AMENDMENTS TO THE DRAWINGS

REMARKS

1/3

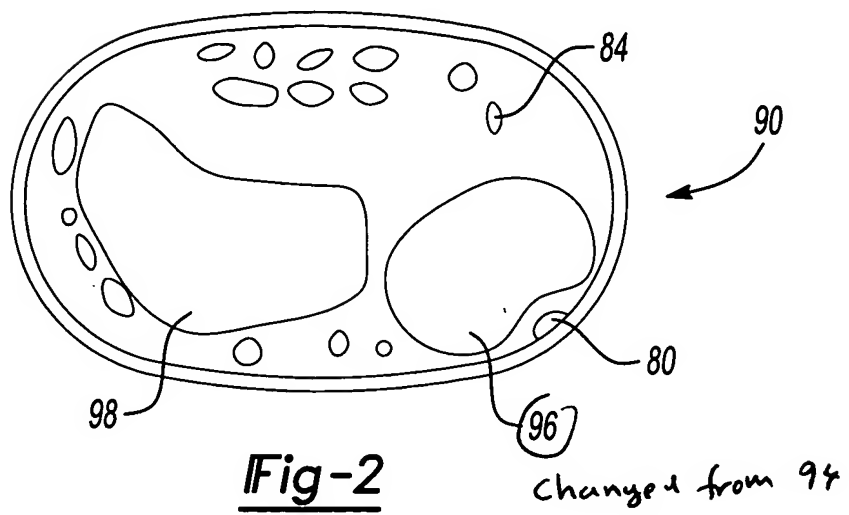
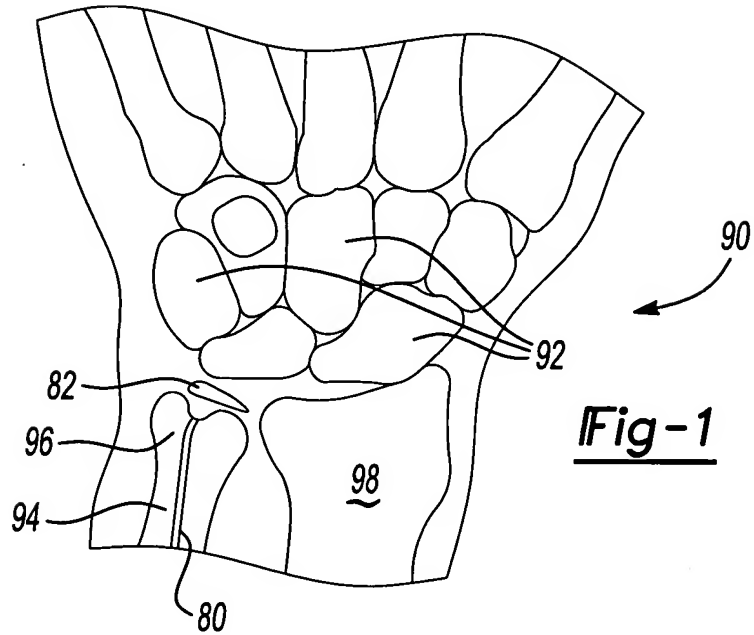
The Replacement Sheets 1 and 3 also include revised Figures 2, 5B and 5C for the Examiner's approval. In each of Figures 2, 5B and 5C, the reference numeral pointing to the ulnar styloid was changed from 94 to 96 to correct an inadvertent typographical error in the Figures. The ulnar styloid is consistently associated in the specification with the reference numeral 96. No new matter has been introduced by this change.
